**Public Information Meeting Notes**  
**January 19, 2021**  
**File 19-15 A**  
**Meadows Development**

## Questions from Lee Chalmers (Falmouth resident) in response to proposed Development Agreement for the Meadows Phase 2 Development

**Todd Richard, Director of Public Works, Response to Lee Chambers Questions on February 23, 2021**

**STORM DRAINAGE /  
ENVIRONMENTAL  
PROTECTION PLAN**

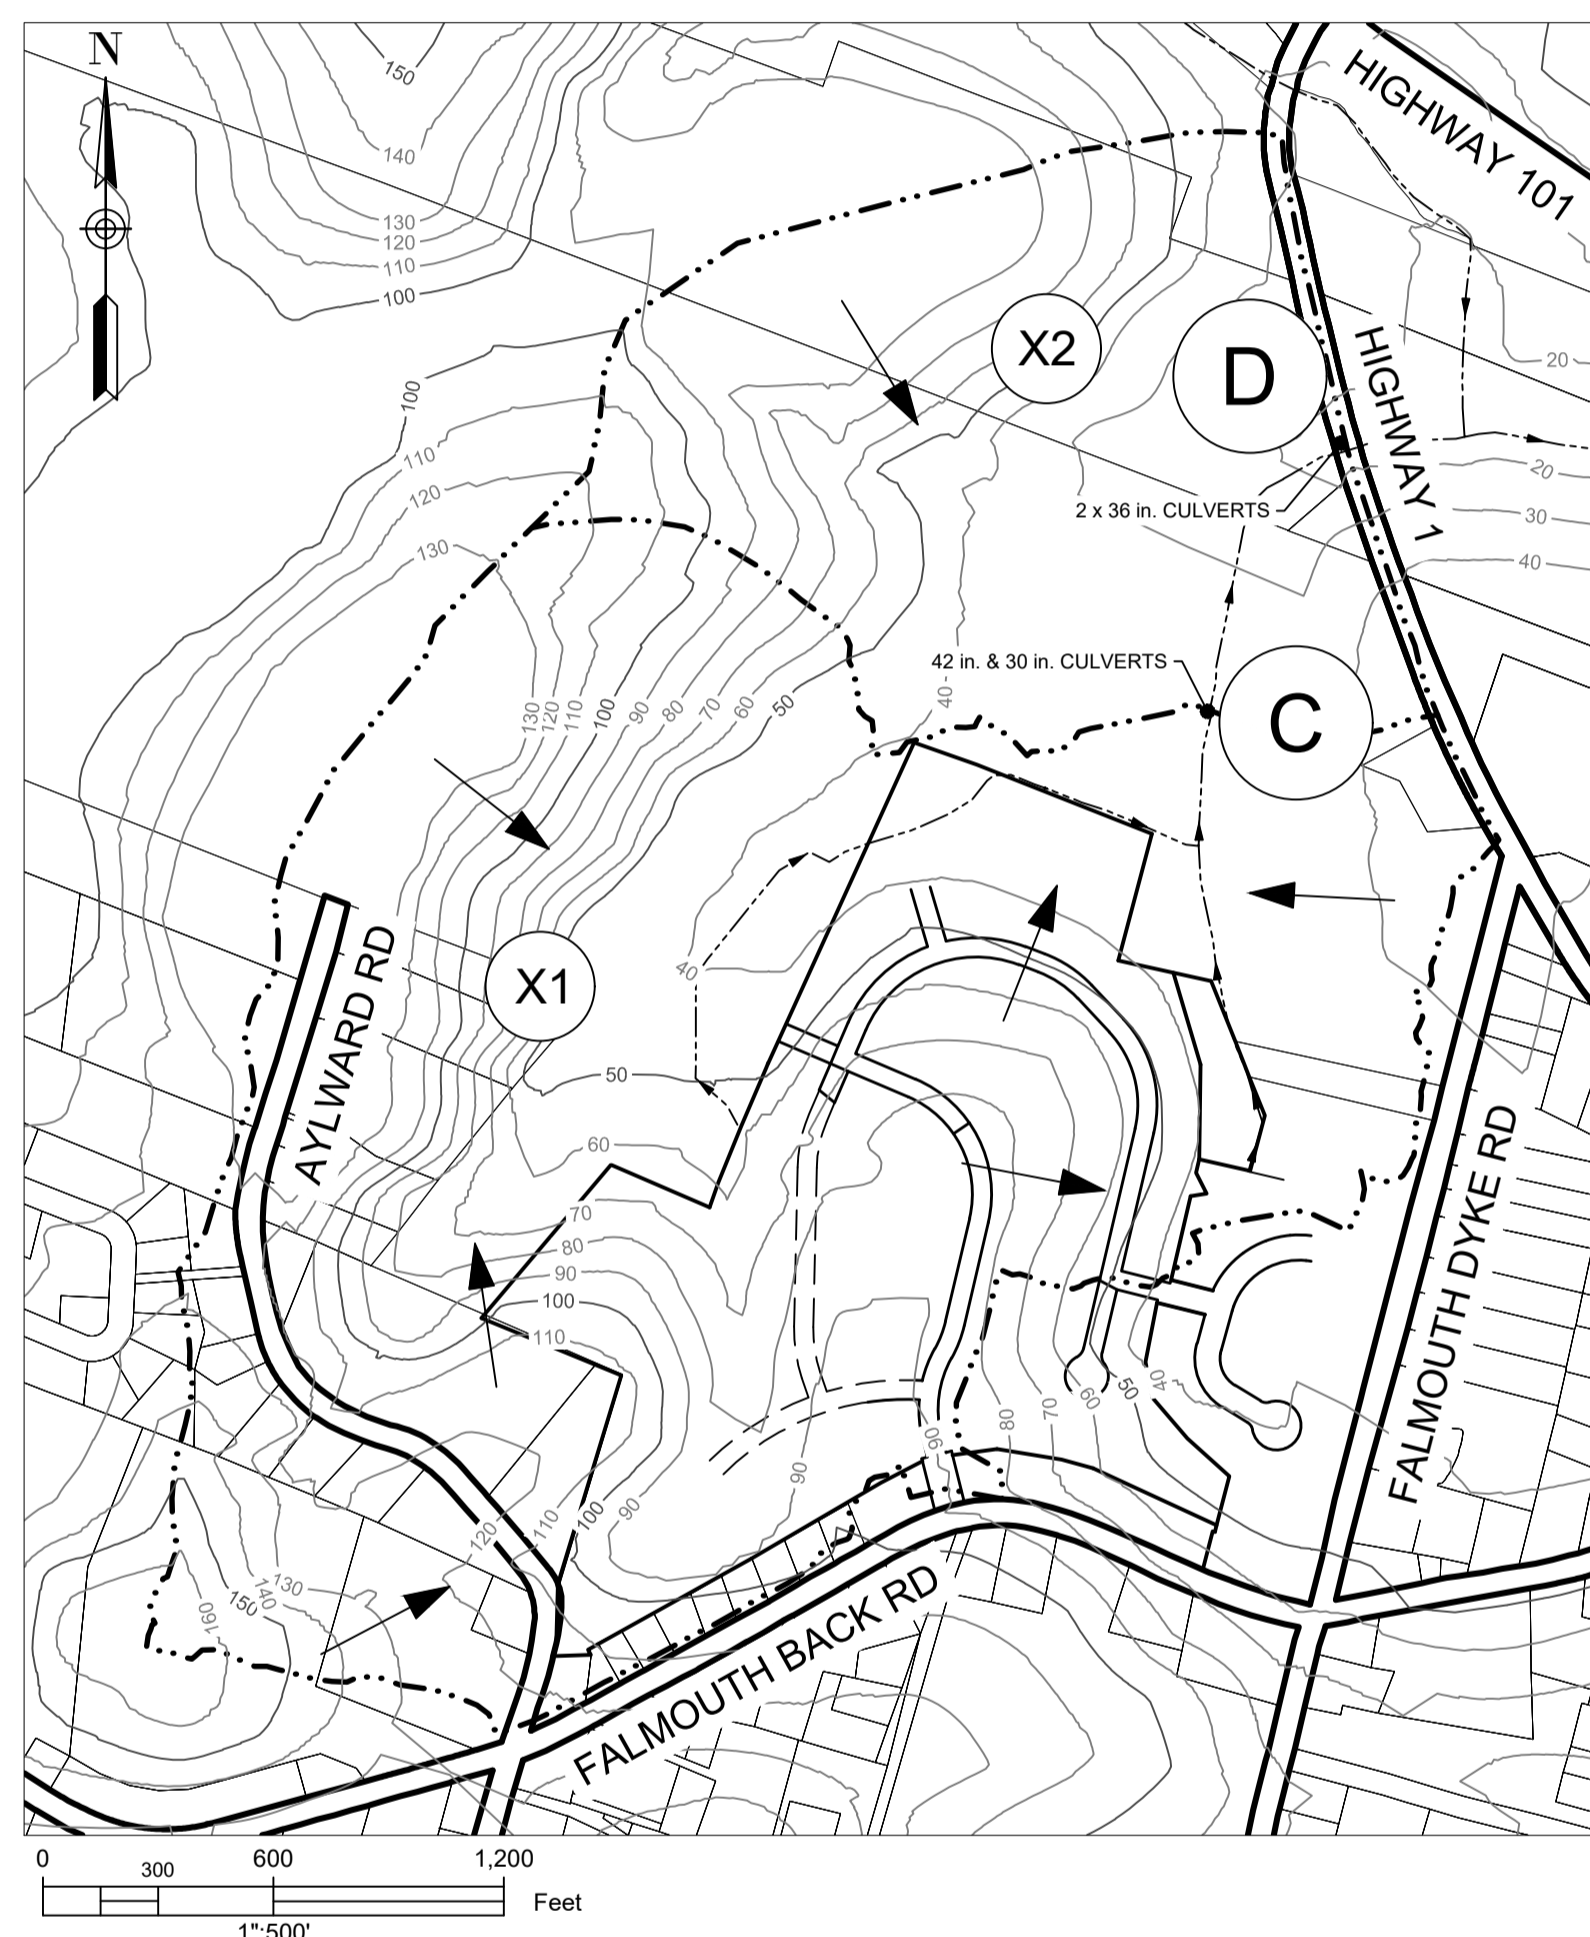
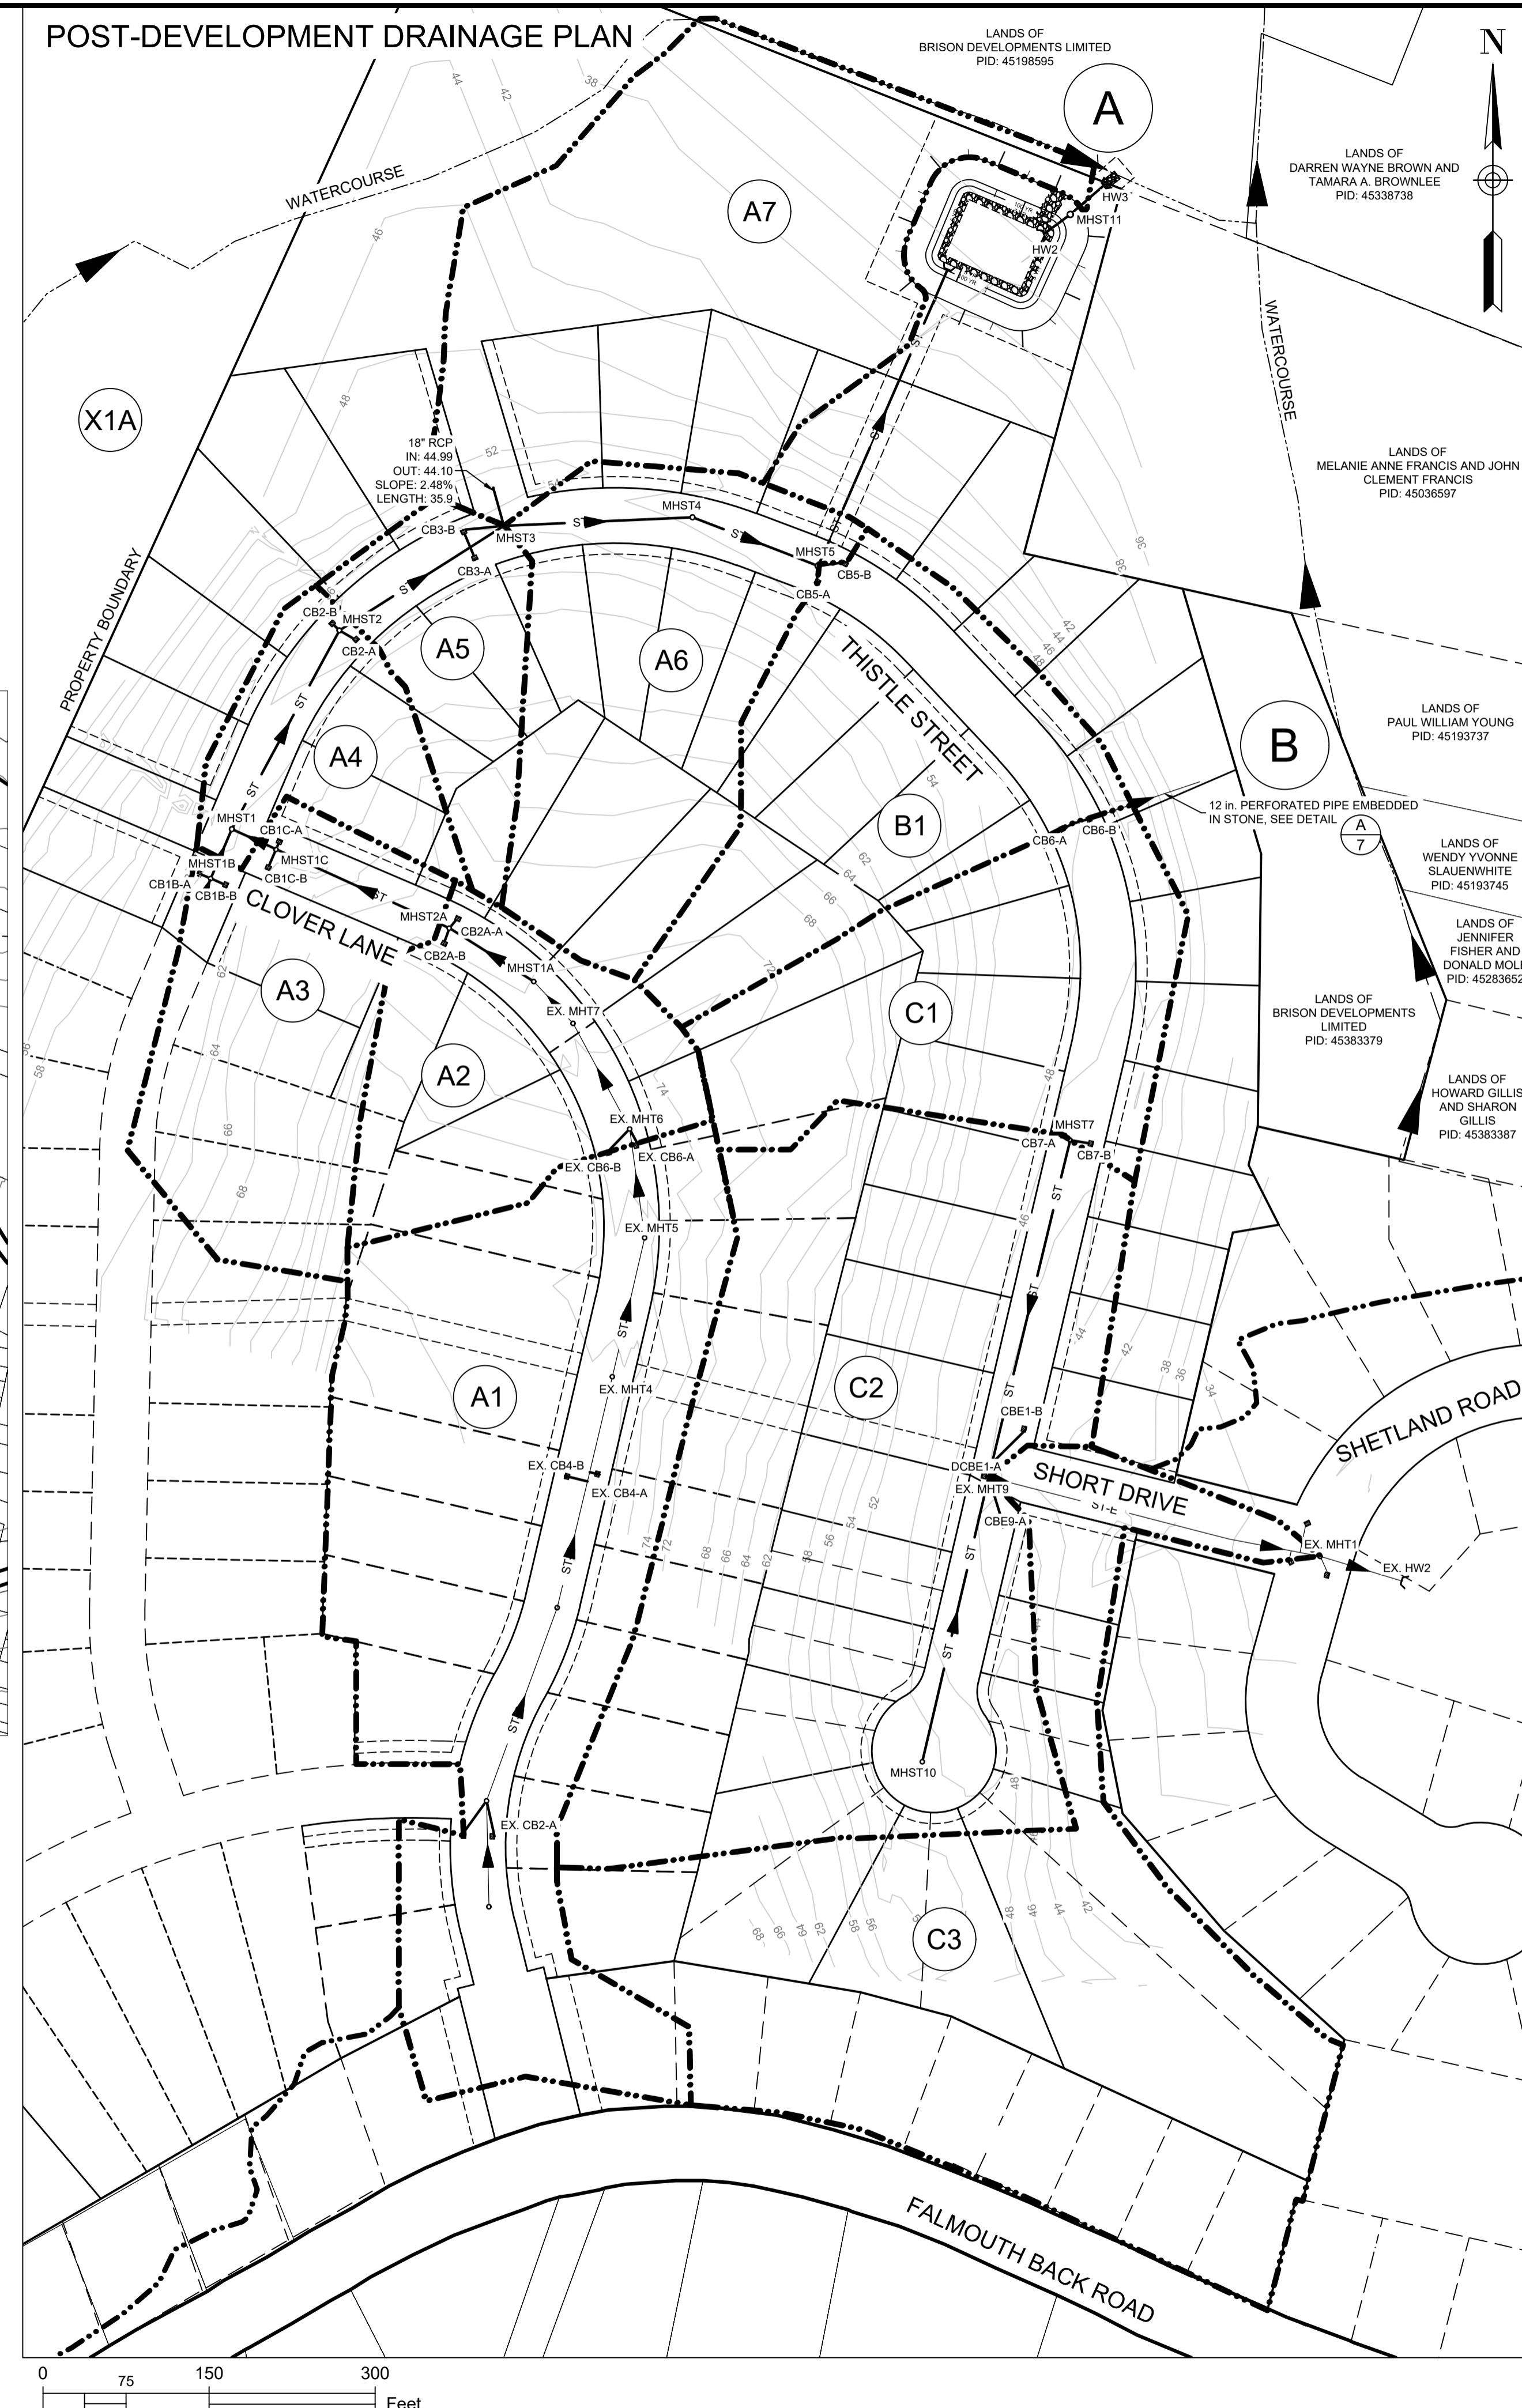
However, I do have some outstanding concerns in this regard. The July 16, 2020 issue (#4) of the Meadows Phase 2 Storm Drainage Environmental Protection Plan (DesignPoint Engineering & Surveying) indicates that post-development flows are expected to be less than pre-development flows for one in 10/25/50/100 year storm events for all four locations examined at the development site.<sup>5</sup> However, post-development flows are expected to exceed pre-development flows at 3 locations on the development site by .02-.19 cfs for a once in 5 year storm event. Comparable data for the Shetland Rd pond outlet and Dyke Rd culvert outlet locations were not presented, but history suggests that monitoring these locations as development proceeds would be prudent.

1. Are there data available that address the question whether the proposed Meadows Phase 2 Development, as configured under the most recent ZZap site plan, is expected to increase flooding risk (as indicated by post-development flows exceeding pre-development flows) for properties on the East side of Falmouth Dyke Rd (where stormwater from the Shetland Rd

pond enters the Elderkin Creek Drainage System through the Dyke Rd Culvert and Connector Ditch), including for one in 2 and one in 5 year storm events?

2. Given the deviations from engineering plans that occurred during construction of the Meadows at Shetland Road stormwater management system in 2005-2006, are mechanisms (e.g., third-party certified construction review) in place to ensure that the stormwater management system for the current phase is constructed according to plan and that post-development flow targets will be met?

Response: The Shetland stormwater pond was originally designed to accept stormwater water from part of the phase 2 Meadows lands and the pre/post balancing will take place in both the new and existing ponds. The designers of the Shetland Road project provided a 30" storm pipe to accommodate stormwater from the Meadows Phase 2 project. This connection has been made and the post development flow from the phase 2 Meadows land to this 30" pipe is approximately 23 cfs., while the pipe capacity is approx.. 29cfs. All indications are that less water will be released East of the Dyke Road.
